# Intel<sup>®</sup> Communications Chipset 8900 Series

Specification Update

*May 2014*

Document Number: 328000-005US

**Figure 2. 1000BASE-BX/FC-Pi Transmitter Electrical Specifications**

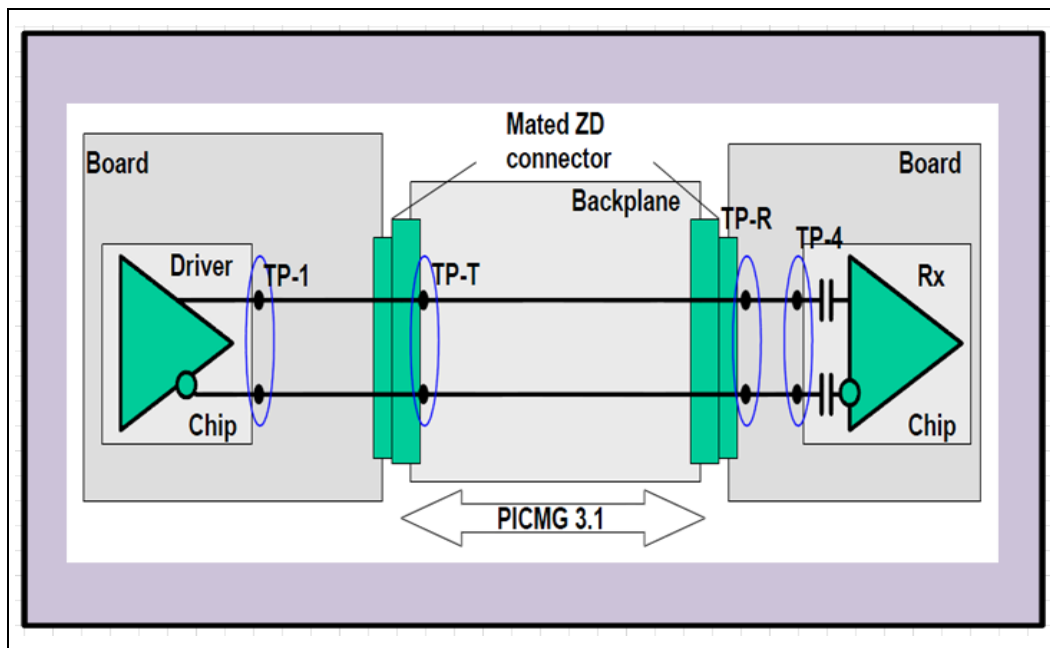
**Implication:** Although this is a specification violation, it does not affect the functional operation of the interface.

**Workaround:** Ensure that the signal routing length from TP-1 to TP-4 is greater than 10". Refer to *Intel® Communications Chipset 8900 Series Platform Design Guide (PDG)* for maximum routing length. (See [Figure 2.](#))
